Town of Hilton Head Island Regular Design Review Board Meeting

REVISED AGENDA

Town of Hilton Head Island
Minutes of the Design Review Board Meeting
December 11, 2018 at 1:15 p.m.
Benjamin M. Racusin Council Chambers

PROPOSED SITE PLAN

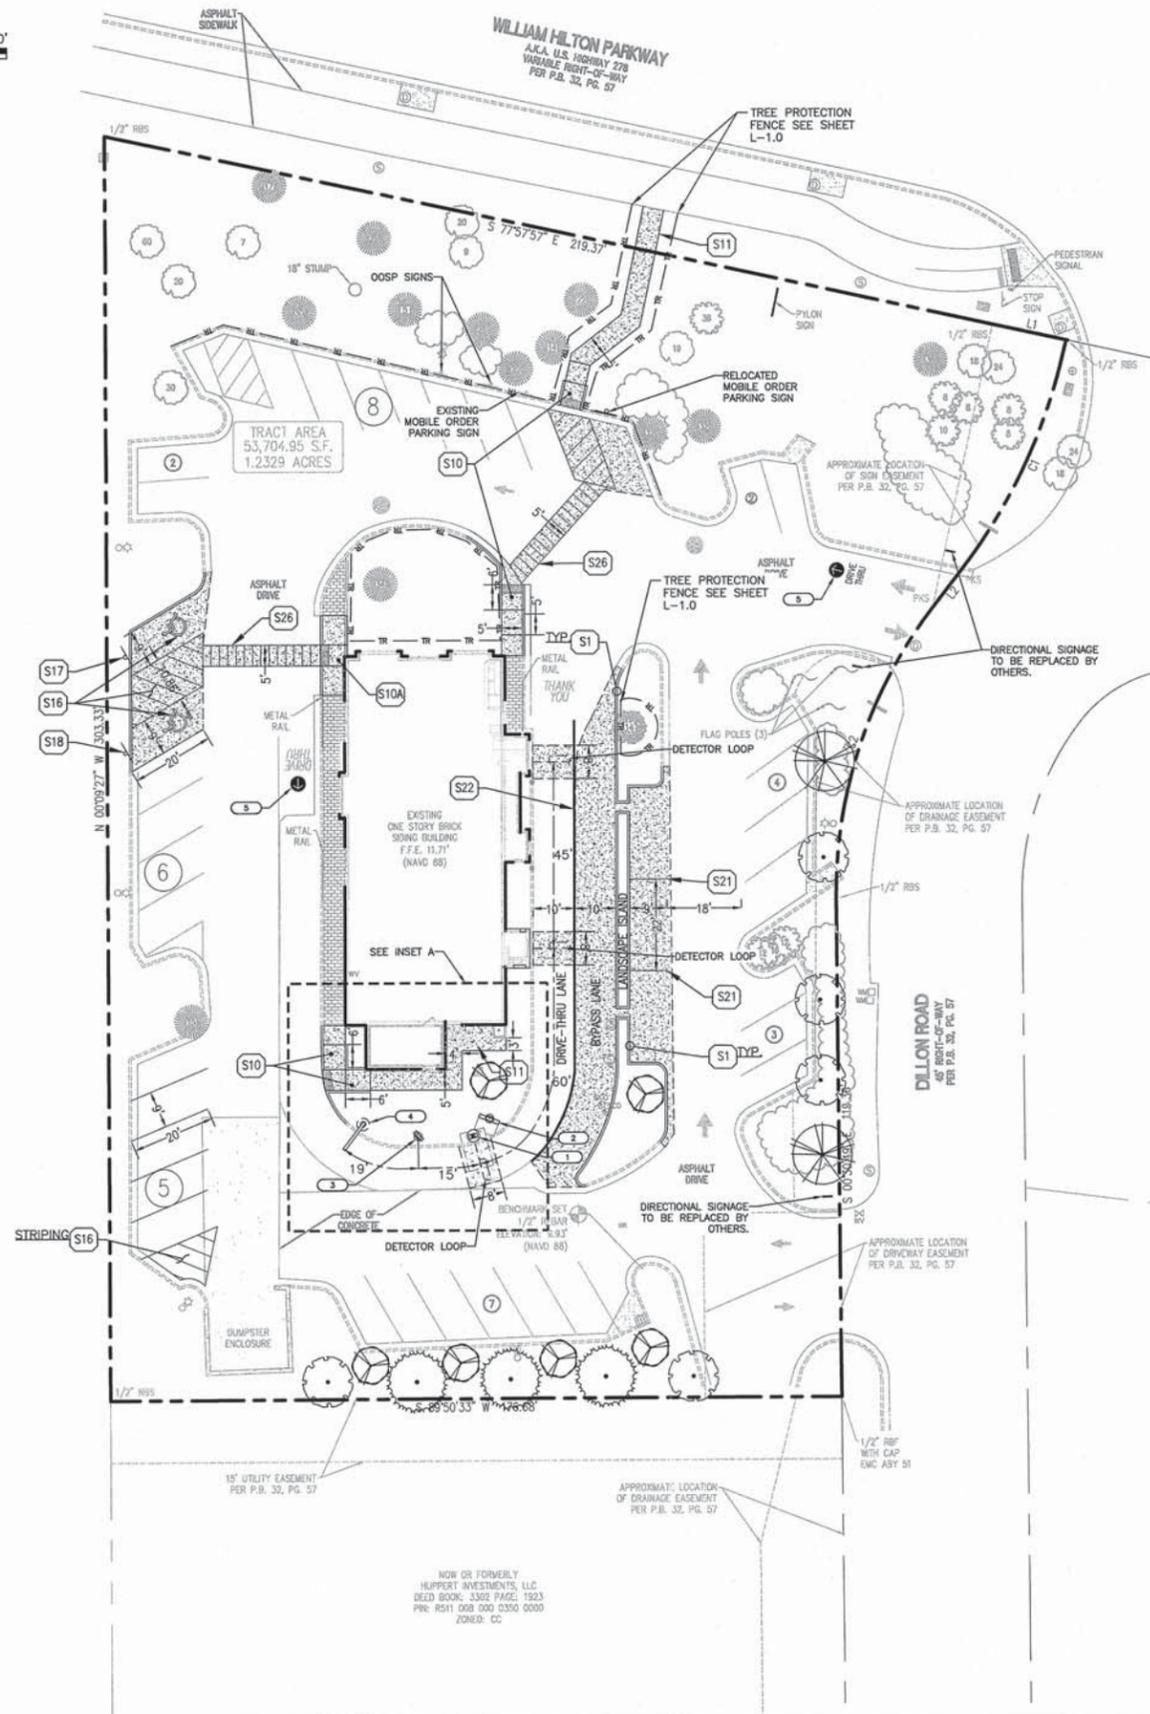
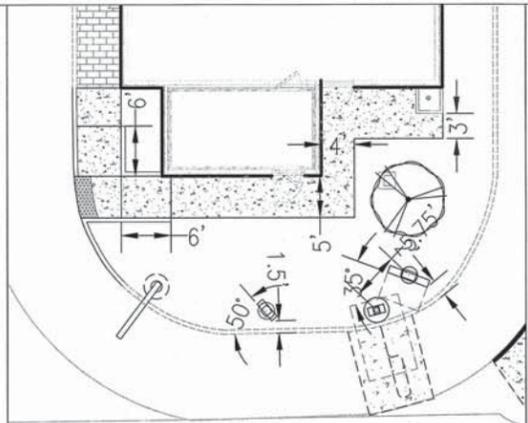
LANDSCAPE DESIGN				
DESIGN GUIDE/LMO CRITERIA	Complies Yes	No	Not Applicable	Comments or Conditions
Treats the Landscape as a major element of the project	<input type="checkbox"/>	<input checked="" type="checkbox"/>	<input type="checkbox"/>	<ol style="list-style-type: none"> 1. Photinia (Red Tip) is not native and suffers from disease. A better plant should be selected (consider; Compact Inkberry, Dwarf Yaupon Holly or Dwarf Wax Myrtle) 2. Carolina Ash suffers from disease and is probably not the best selection for a parking

lot landscape island. A better plant should be selected (consider; Live Oak, Bald Cypress, Pignut Hickory, Longleaf Pine). 3. Screen the dumpster enclosure.
Provides Landscaping of a scope and size that is in proportion to the scale of the development	<input type="checkbox"/>	<input checked="" type="checkbox"/>	<input type="checkbox"/>	Add planting / ground cover to the landscape island in front of the building.
Preserves a variety of existing native trees and shrubs	<input type="checkbox"/>	<input checked="" type="checkbox"/>	<input type="checkbox"/>	Why are the 18" and 25" at the menu board being removed? Consider maintaining them.
Location of existing trees and new trees provides street buffers, mitigation for parking lots, and an architectural complement that visually mitigates between parking lots and building(s)	<input type="checkbox"/>	<input checked="" type="checkbox"/>	<input type="checkbox"/>	Add canopy trees (consider; Live Oak, Bald Cypress, Pignut Hickory, Longleaf Pine) to the landscape islands where none exist: 1. across the drive-thru isles from the menu board instead of Fringetree 2. opposite back entrance 3. right side of back entrance instead of Dahoon Holly 4. at dumpster enclosure 5. left side of front entrance 6. opposite the building front entrance (landscape island is empty)

A variety of sizes is selected to create a "layered" appearance for visual interest and a sense of depth	<input type="checkbox"/>	<input checked="" type="checkbox"/>	<input type="checkbox"/>	The planting plan lacks groundcovers and or smaller shrubs. Will the area be mulched?
Proposed groundcovers are evergreen species with low maintenance needs	<input type="checkbox"/>	<input checked="" type="checkbox"/>	<input type="checkbox"/>	See above

1 REAR ELEVATION
 A2.0 1/4" = 1'-0"

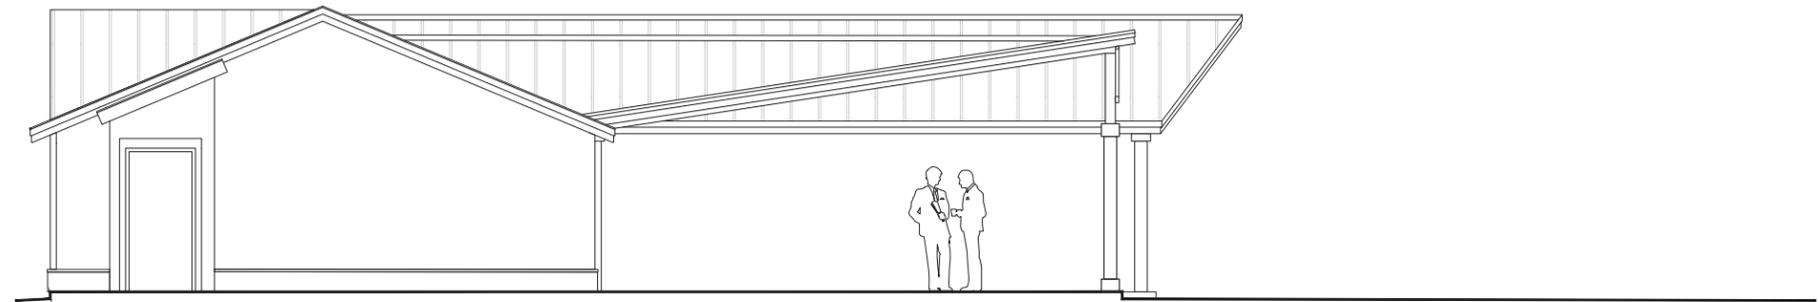
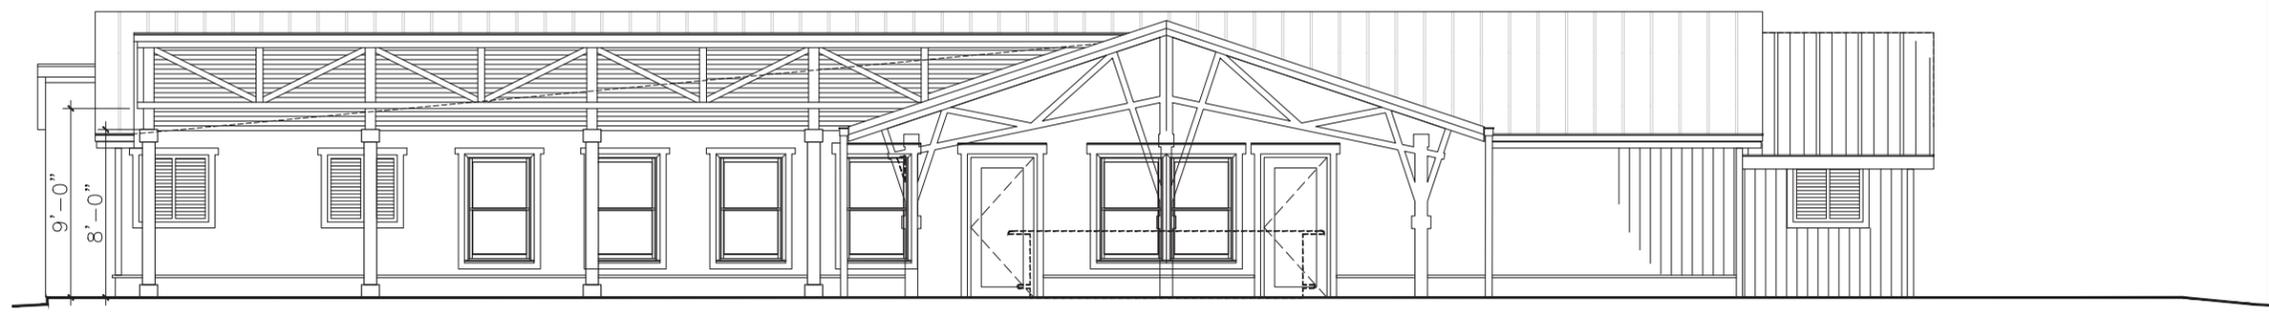
<i>ARCHITECTURAL DESIGN</i>				
DESIGN GUIDE/LMO CRITERIA	Complies Yes	No	Not Applicable	Comments or Conditions
Has a strong roof form with enough variety to provide visual interest	<input type="checkbox"/>	<input checked="" type="checkbox"/>	<input type="checkbox"/>	Architecture and building system should relate to the existing structure. The reverse shed roof looks foreign to the structure. Consider a gable parallel to the bar gable.
Minimum roof pitch of 6/12	<input type="checkbox"/>	<input checked="" type="checkbox"/>	<input type="checkbox"/>	While a roof pitch of 6/12 is not required, given the size of the addition, matching the existing pitch or providing any discernable pitch is preferable.
Overhangs are sufficient for the façade height.	<input type="checkbox"/>	<input checked="" type="checkbox"/>	<input type="checkbox"/>	Electrical lines should be concealed. Add notes to

plans to specify.
Decorative lighting is limited and low wattage and adds to the visual character	<input type="checkbox"/>	<input checked="" type="checkbox"/>	<input type="checkbox"/>	Provide a lighting plan.
Accessory elements are design to coordinate with the primary structure	<input type="checkbox"/>	<input checked="" type="checkbox"/>	<input type="checkbox"/>	Cut sheets for ceiling fans and or light fixtures will need to be provided.

PROPOSED SECTION

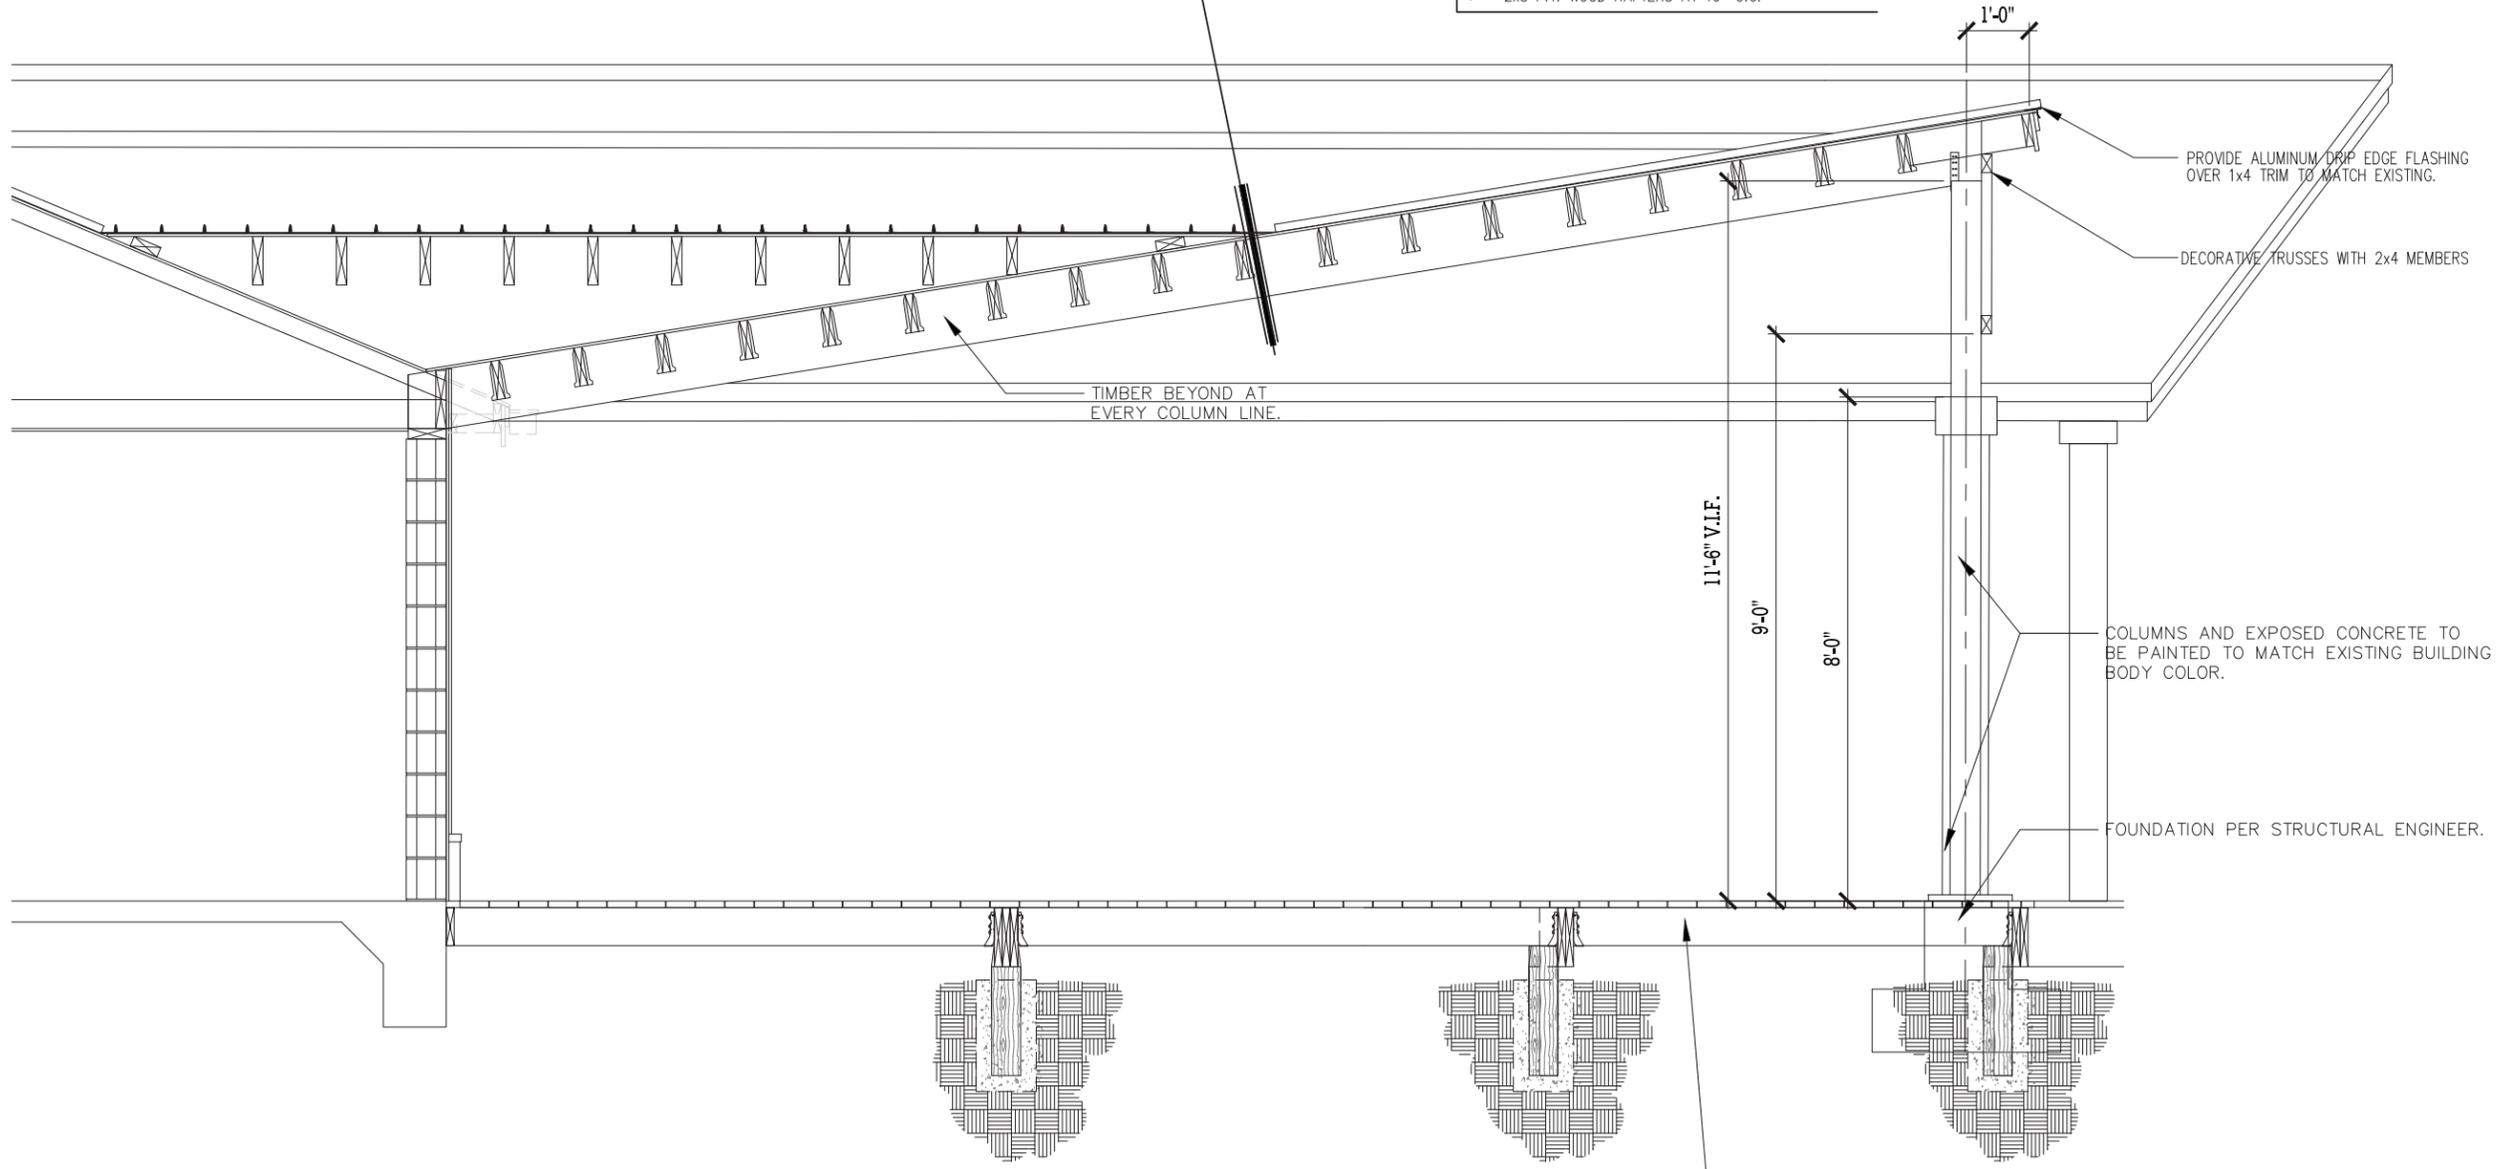
<i>APPLICATION MATERIAL</i>				
DRB REQUIREMENTS	Complies Yes	No	Not Applicable	Comments or Conditions
Dimensioned Details and of Sections	<input type="checkbox"/>	<input checked="" type="checkbox"/>	<input type="checkbox"/>	Details and sections are too conceptual. It is not clear that the proposed columns are wood.
Detail Illustrating Connection to Existing Structure	<input type="checkbox"/>	<input checked="" type="checkbox"/>	<input type="checkbox"/>	Too conceptual
New Building Details Match Existing Building Details	<input type="checkbox"/>	<input checked="" type="checkbox"/>	<input type="checkbox"/>	Consider another roof ridge / gable parallel to the gable over the bar.
